Subject: Erratum 1 (05/2005) to

ITU-T Recommendation G.7042/Y.1305 (02/2004) Corrigendum 1 (08/2004), *Link capacity adjustment scheme (LCAS) for virtual concatenated signals*

G.7042/Y.1305CORR.1_FA2

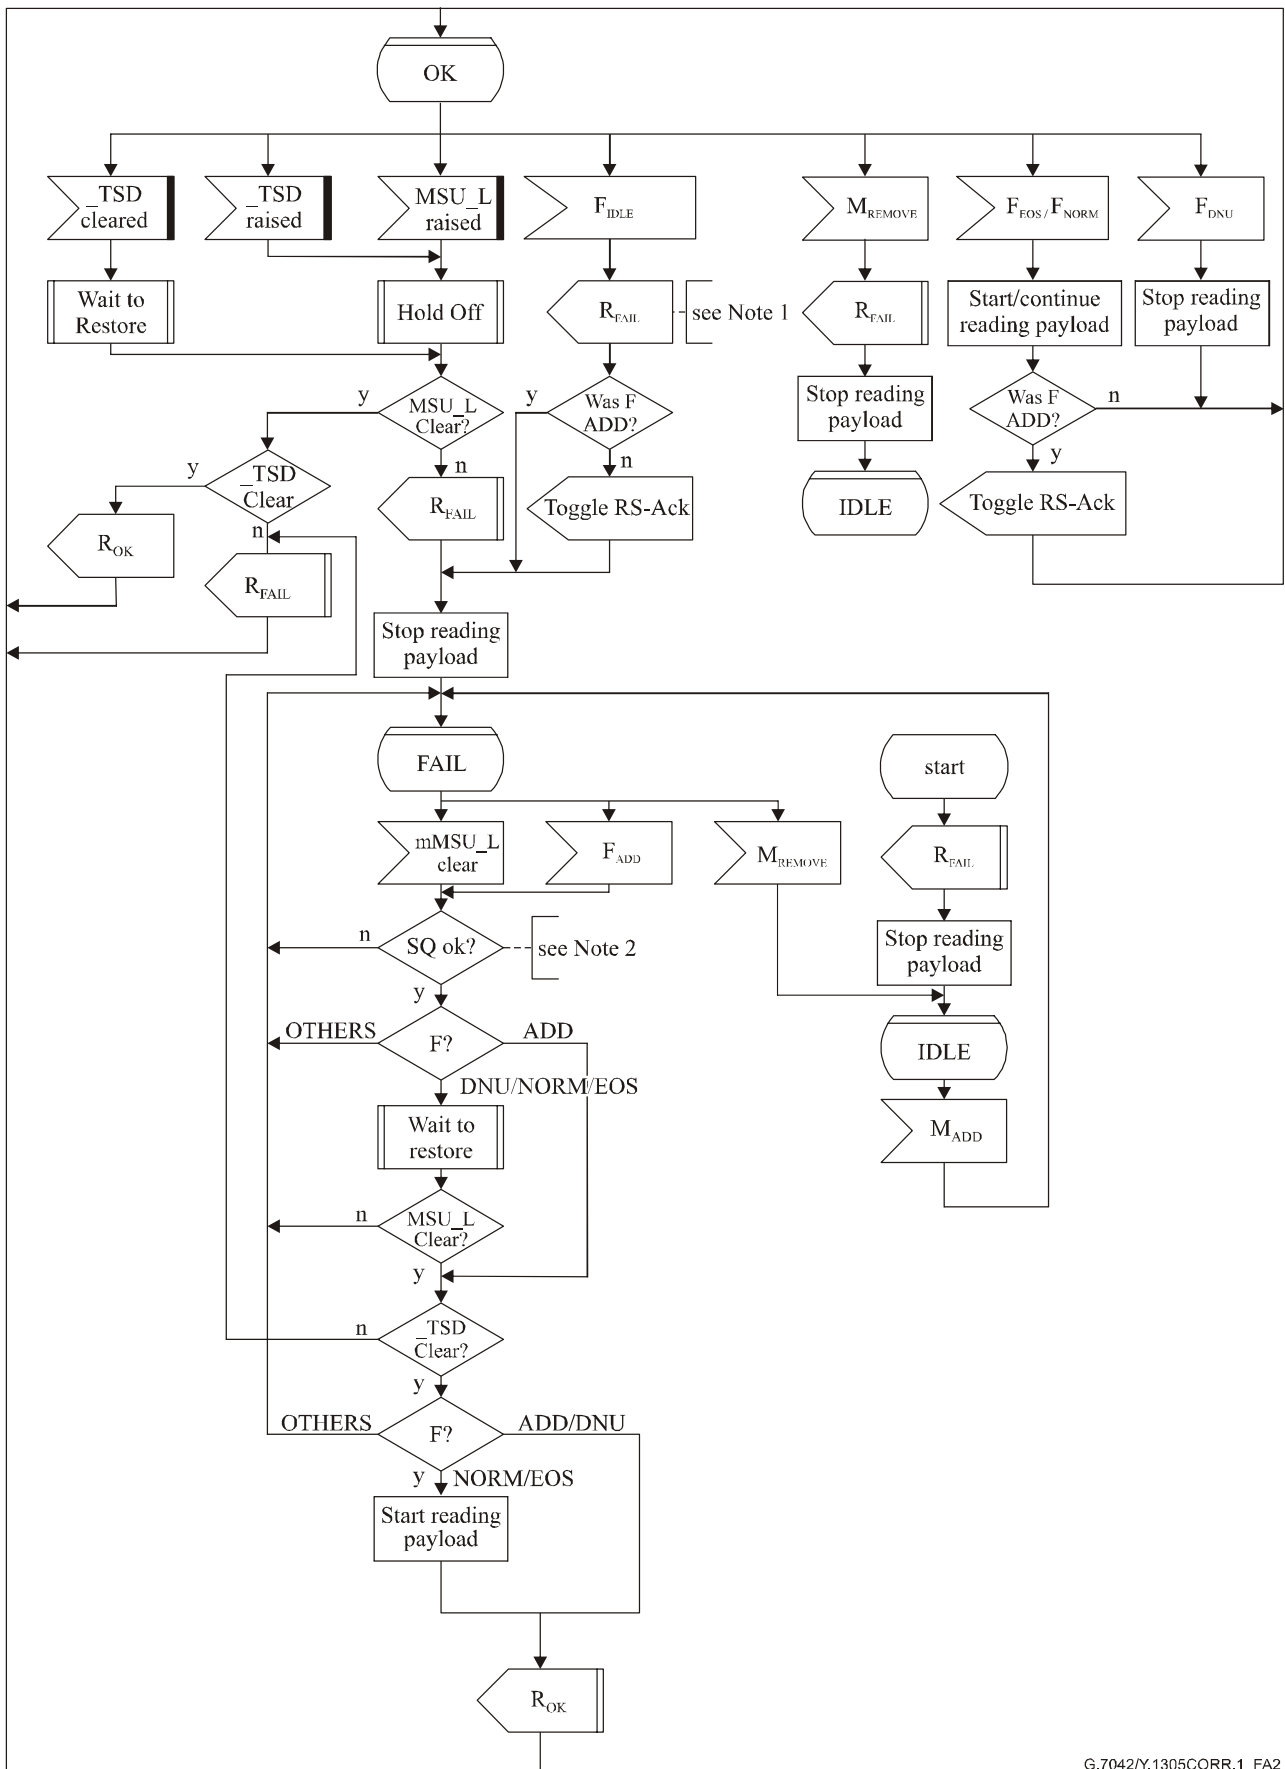
Replace Figure A.2/G.7042/Y.1305 "Sink side state diagram" by the following, in order to correct the task box before entering the "FAIL" state, from "~~Start~~ reading..." to "Stop reading...":
